JUNCTION CITY PLANNING COMMISSION

AGENDA ITEM SUMMARY

THE RESERVE AT JUNCTION CITY PHASES 3-6 (FILE # SUB-22-16)

PLANNING DEPARTMENT STAFF REPORT AND FINDINGS:

ADA impact at new proposed 10th Ave connection

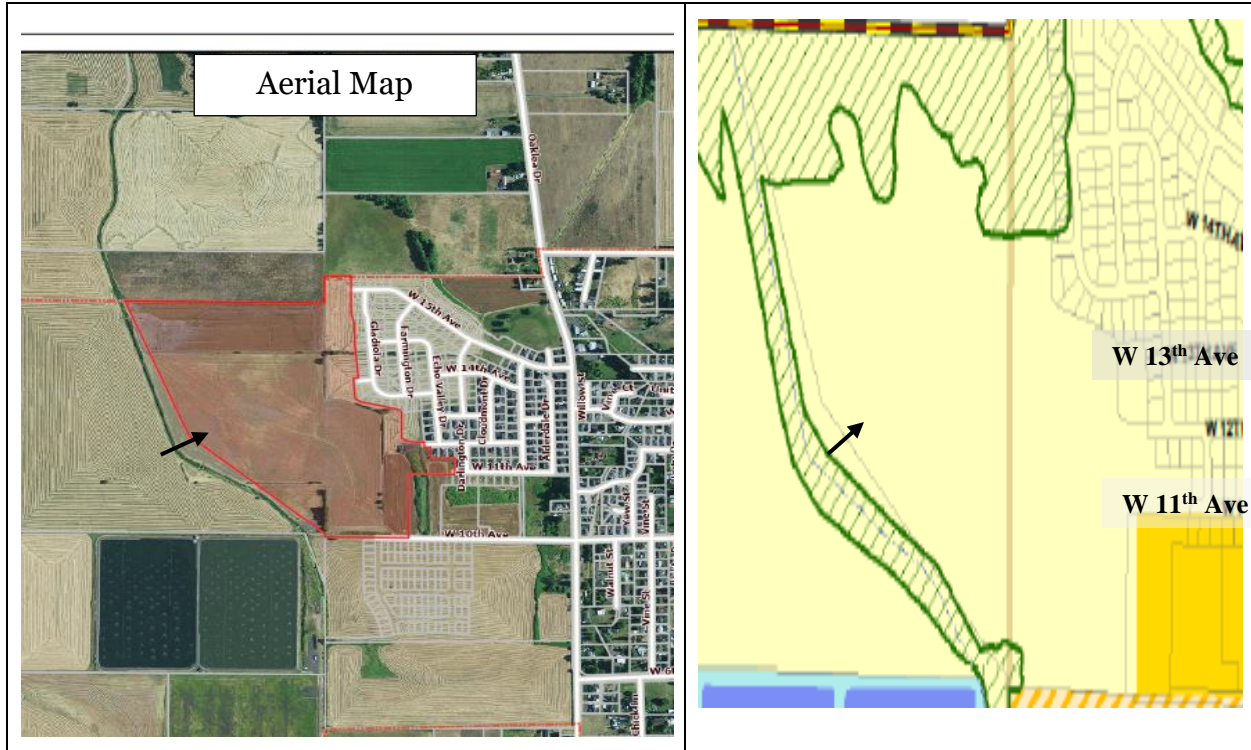
- The TIA does not address the gap in pedestrian connectivity on the west side where the Reserve Phase 2 left off. Where crossing needs are identified, additional enhancements may be warranted. A comprehensive bike ped traffic generation analysis (Mode Choice) is required for the entire Reserve phases.

- Lane County scope of study includes a review of completed frontage and roadway improvements with applicable Lane Code requirements. Please provide an analysis of 10th Ave intersection improvement status and identify deficiencies relative to current ADAAG, PROWAG and Lane County Code specific requirements.
- An analysis of required transitions between improved and unimproved sections and identification of a responsible party is required.
